Seabrook Station
Reply to Inspection Report 2000-11

REPLY TO INSPECTION REPORT 2000-11

NORTH ATLANTIC'S ALTERNATIVE PERSPECTIVES
TO ISSUES DESCRIBED
IN NRC INSPECTION REPORT 2000-11

EMERGENCY DIESEL GENERATOR B OPERABILITY DURING CYCLE 7

FIGURE 1
EDG-B Cycle 7 Lubricating Oil Strainer Delta-P

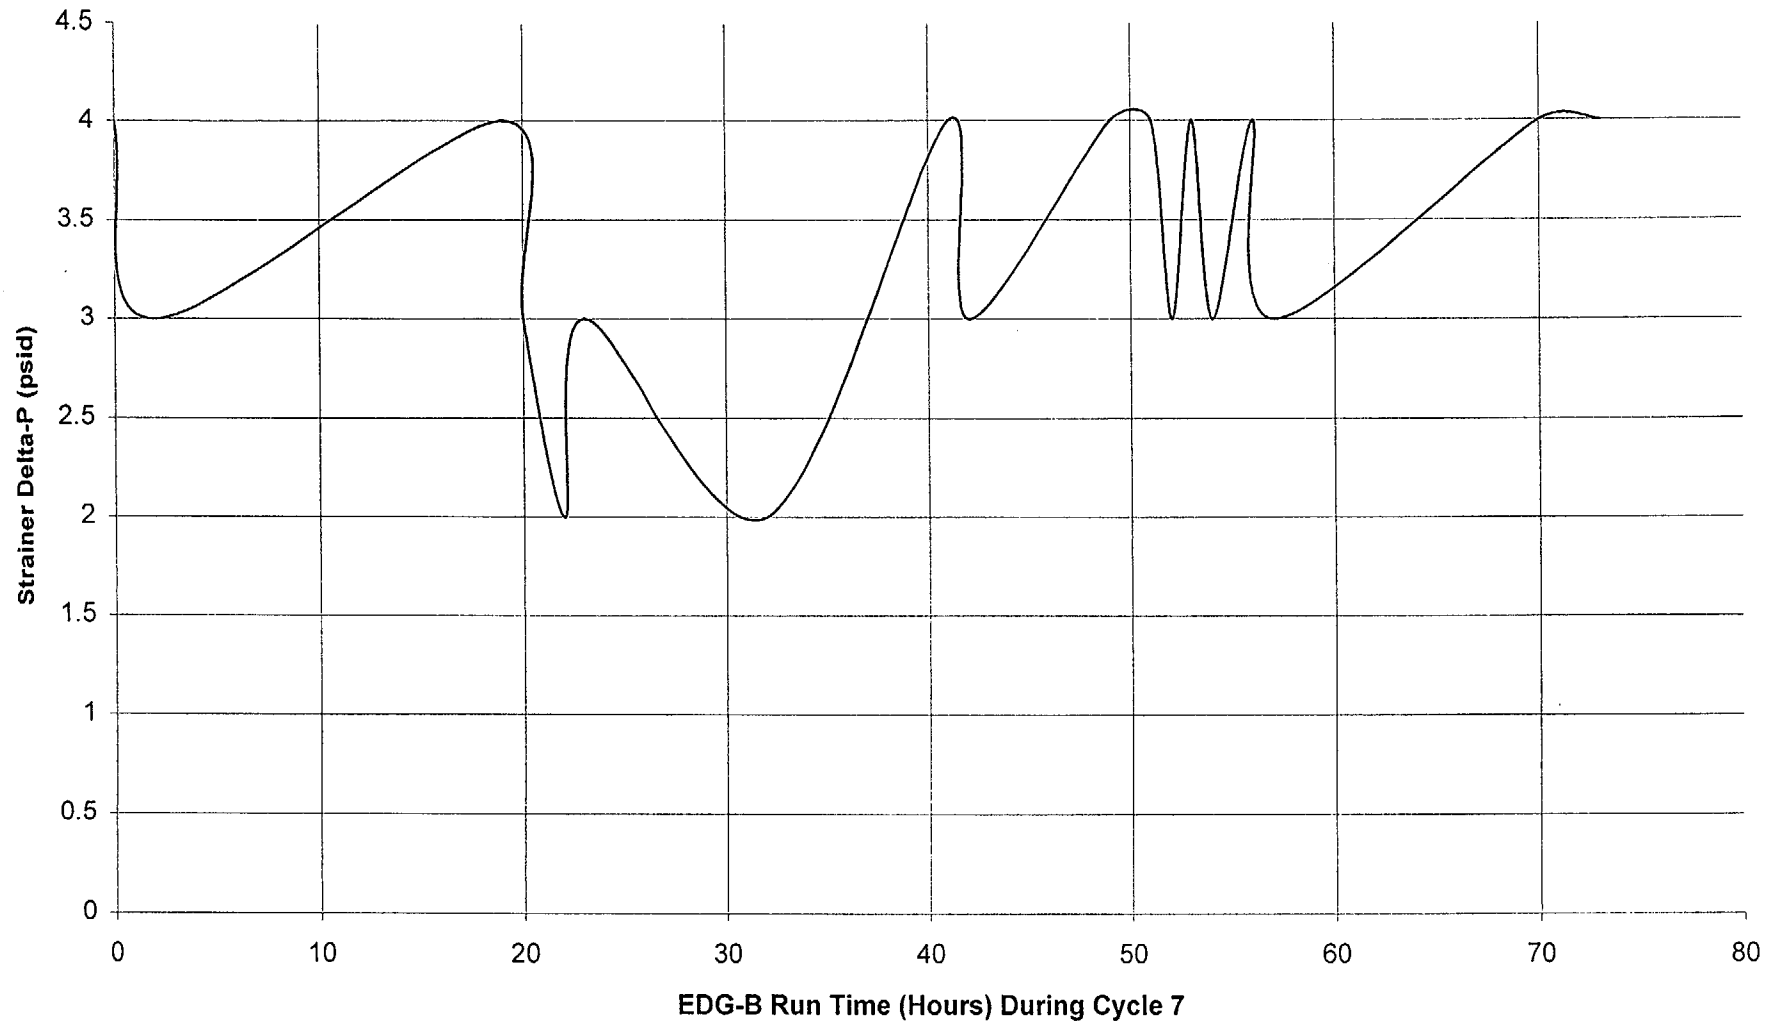
EDG-B lubricating oil strainer differential pressure remained within a normal range of approximately 2 to 4 psid throughout cycle 7. This is depicted on Figure 1. No lubricating oil strainer replacements or cleanings were required during the cycle. Prior to OR-07, the last time the strainers were replaced was in March 1997.

FIGURE 2
OR-07 EDG-B Lubricating Oil Strainer Delta-P

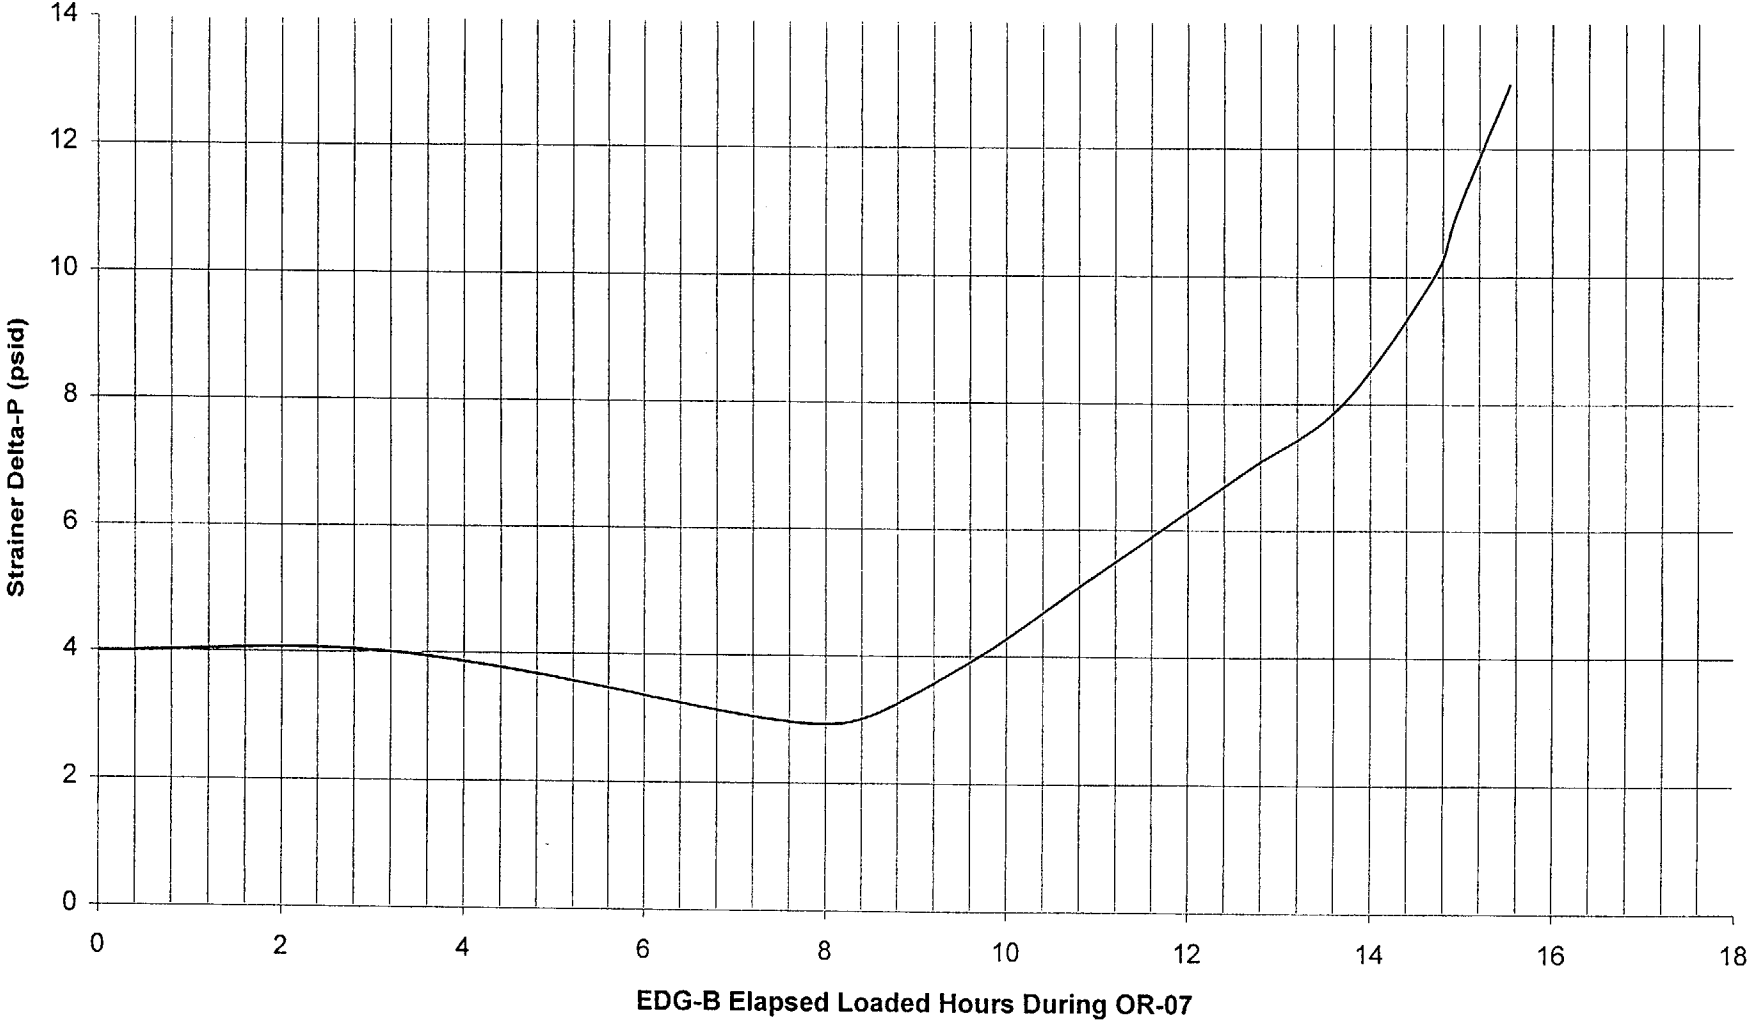
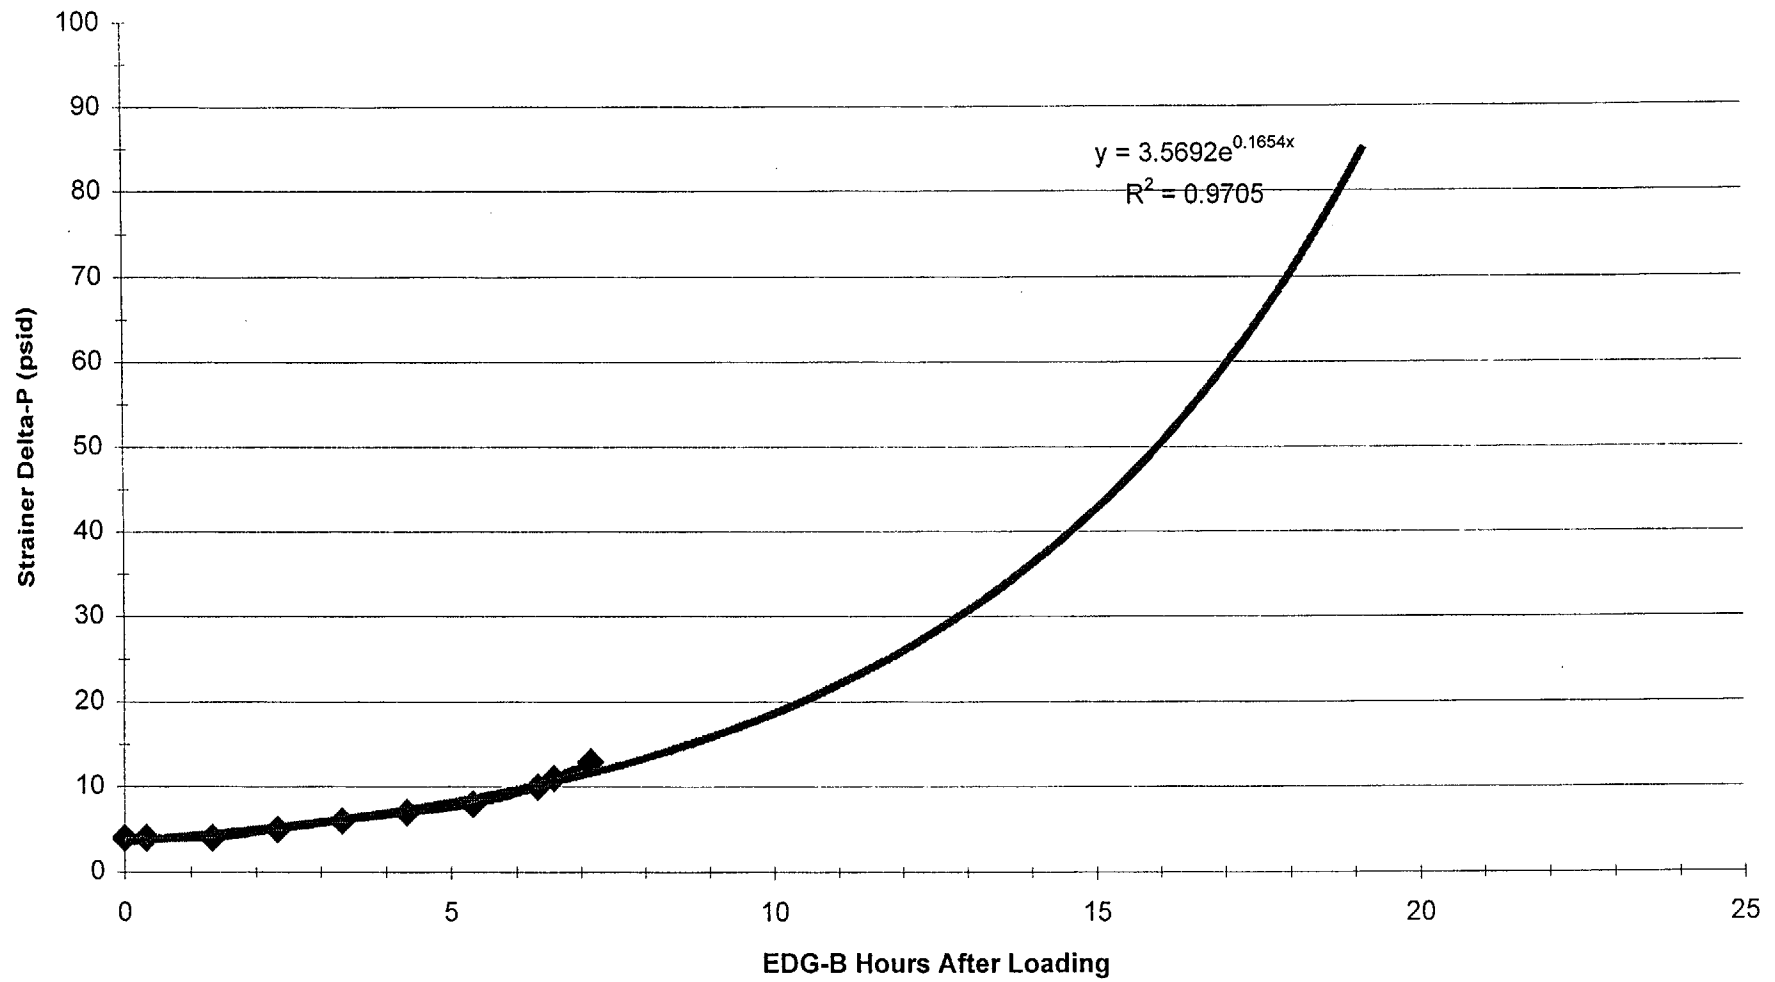
In contrast, rapid increases in lubricating oil strainer differential pressure were noted during the first attempt to complete the 24-hour surveillance run made on October 29, 2000. During the 7 hour 50 minute run, the differential pressure increased from approximately 4 psid to 13 psid. The strainer elements were then replaced with cleaned elements. Similarly, a differential pressure increase was noted during the third attempt to complete the 24-hour surveillance run. During a 22-hour period, the strainer differential pressure increased from 2 psid to 7 psid. The strainer elements were replaced again, the lubricating oil was changed, and the engine failure occurred shortly thereafter during the fourth attempt at the 24-hour run on November 1, 2000. Figure 2 depicts the EDG-B lube oil strainer differential pressure that was recorded each hour during OR-07 through the first attempt at the 24-hour run on October 29, 2000. This further demonstrates that the engine failure was initiated during the refueling outage.

The above estimate utilized an Excel program to extrapolate the strainer data collected during that run to roughly estimate when the engine would have tripped on low lubricating oil pressure. To more accurately model the entire run on October 29, 2000, the extrapolation included an estimate of the initial strainer differential pressure from the start of the run along with actual strainer readings taken during the run. This analysis also accounted for the auxiliary lubricating oil positive displacement pump, which starts prior to an engine trip on low lubricating oil pressure, such that the strainer differential pressure can reach 50 psid before the engine trips. Refer to Figure 3 for a depiction of the strainer differential pressure associated with the first 24-hour run on October 29, 2000. While there are some uncertainties associated with the extrapolation, such as accuracy of gauges, lubricating oil pressure trip setpoints, auxiliary oil pump start and relief pressure, etc., it provides a rough estimate of how long the engine would have operated for successfully during that run.
